Inconsistent signal detect rules

(comments I-433, I-436, R1-289, R1-290,
R1-291, R1-292, R1-293, R2-197)

Piers Dawe

Comment R2-197

Figure 180–2—Block diagram for 800GBASE-DR4 transmit/receive paths

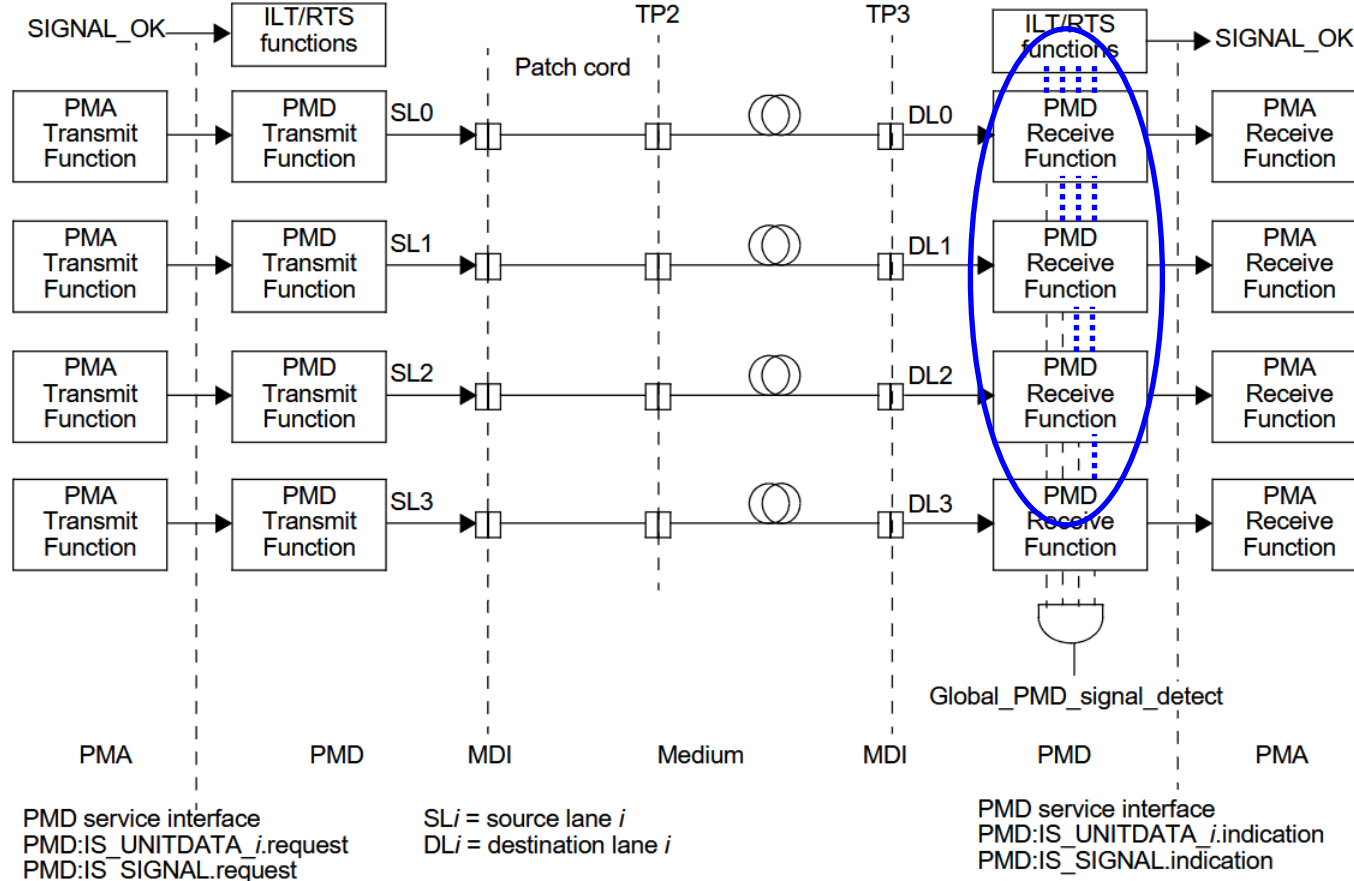
- R2-197 SC 180.5.1 P 468 L 27 TR
- As previously pointed out, Figure 180-2 (block diagram) indicates that signal detect is disconnected from SIGNAL_OK, contrary to all optical PMDs. 180.5.5 says "This standard imposes no response time requirements on the generation of the PMD_signal_detect_i variable." It turns out that they are connected and timing is important: see 178B.8.3.1 as revised: rx_ok "it shall be set to false when an input signal corresponding to tx_disable = true in the peer is received for 100 ms (the minimum duration of the quiet_timer) or longer". As the criterion for tx_disable = true is Average launch power of OFF transmitter ≤ -15 dBm, which is the criterion in Table 180-5, Signal detection criteria for each lane: "Average optical power at TP3 ≤ -15 dBm", signal detect IS required, AND its timing is required (which is new and would surprise optical engineers if they read it).

- Add lines to show that lane-by-lane SD goes to APSU
- Or, remove the lines, the gate and Global_PMD_signal_detect, to match Tx , and because we don't usually draw individual management status variables in block diagrams

- In Figure 180-2 and similar, remove the lines, the gate and `Global_PMD_signal_detect`, to match Tx, and because we don't usually draw individual management status variables in block diagrams
- Move 180.5.4 PMD global signal detect function, and 180.5.5 PMD lane-by-lane signal detect function, to become subclauses of 180.5.3 PMD receive function
- In 180.5.5 add NOTE—Signal detect is not to be confused with `rx_ok` (see 178B.7.2 and 178B.8.3)
- In 180.5.12 Autonomous path startup (APSU) functions, add NOTE—These functions, including `rx_ok` (see 178B.7.2 and 178B.8.3) are not the signal detect functions in 180.5.4 [now 180.5.3.2] PMD global signal detect function, and 180.5.5 [now 180.5.3.2]
 - Similarly in other clauses

- Revise Figure 180-2 and 180.5.5 to be consistent with 178B.8.3.1, with appropriate cross-references. Similarly in other optical clauses.
